REVIEW COMMENTS

FILE #SPR-96-223

TITLE HEADING: Commerce Plaza

Written Response from Petitioner Mark L. Gamble

GRADING & DRAINAGE PLAN

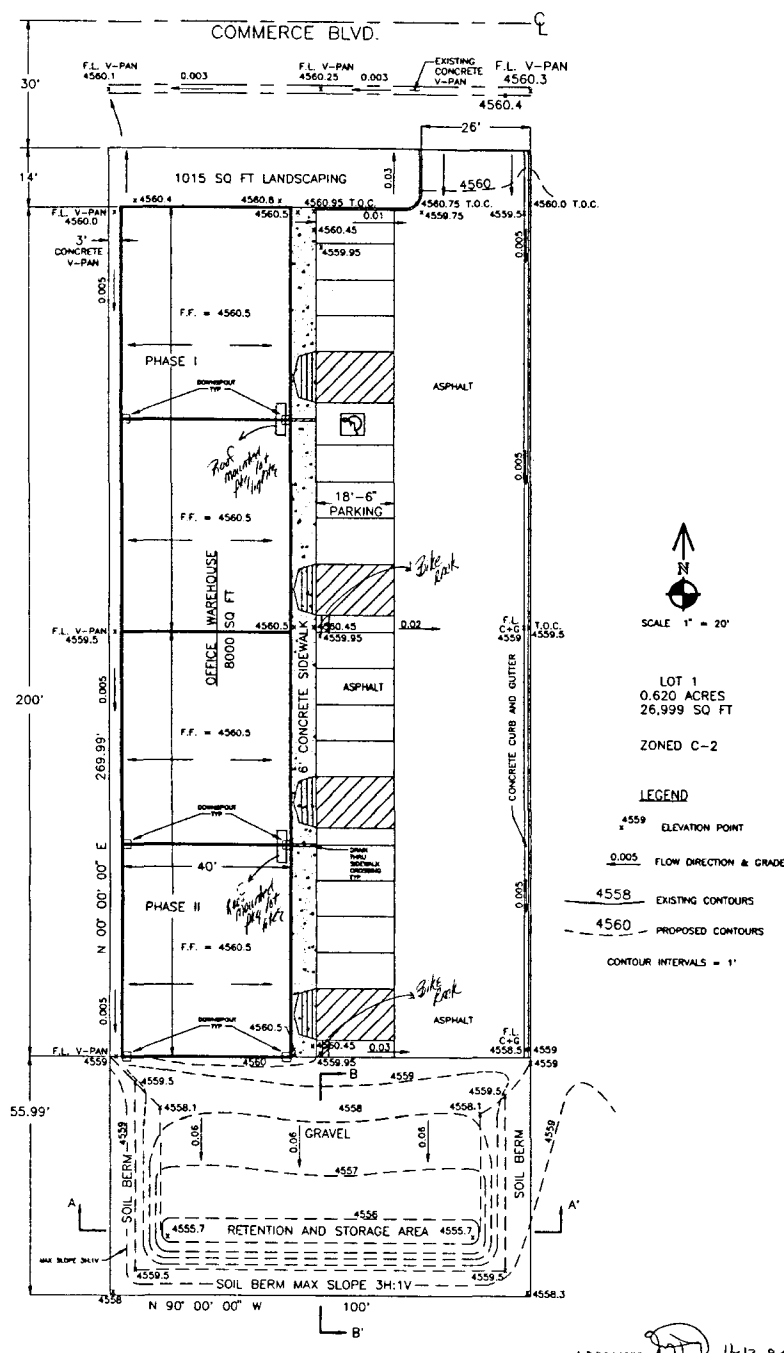
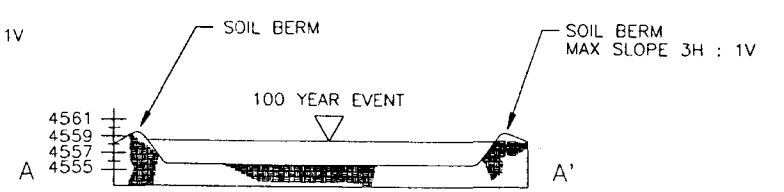
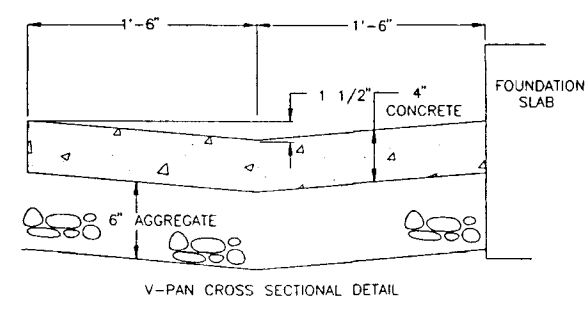
1. If phasing as shown on plans is proposed, the applicant will be required to construct the entire retention pond with Phase I and is required to show on the plans how the water will be conveyed from Phase I to the stormwater facility.

The Petitioner will construct the entire retention pond with Phase I development.

As shown on original drawings, the concrete V-pan on the west property line and the curb and gutter on the east property line will be extended to the retention pond during Phase I development.

SITE/LANDSCAPE PLAN

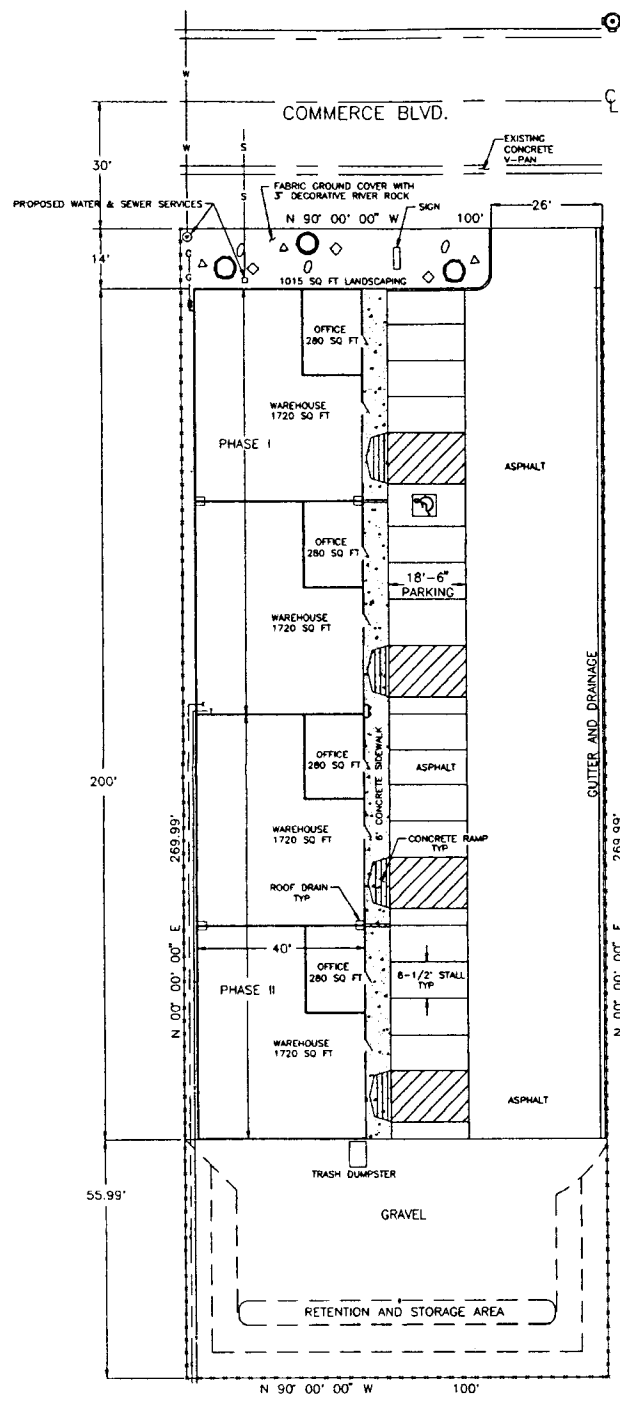
2. Bicycle parking is required by Code; indicate location on plans and provide detail on the type of rack proposed.

Would like to have 2 outside lights in the parking area. One light could be in the middle of office #1 and #2 in Phase I of the project. Later in Phase 2, the other light would be in the middle of offices #3 and #4.

See attached drawings labeled Exhibit "A". A three (3) bike "A" rack will be located at two locations on the property. See revised drawings indicating locations.

I agree with the placement suggested by Police Department. I will place 1 parking light between Units #1 and #2 during Phase I and between Units #3 and #4 during Phase II. See revised drawing.
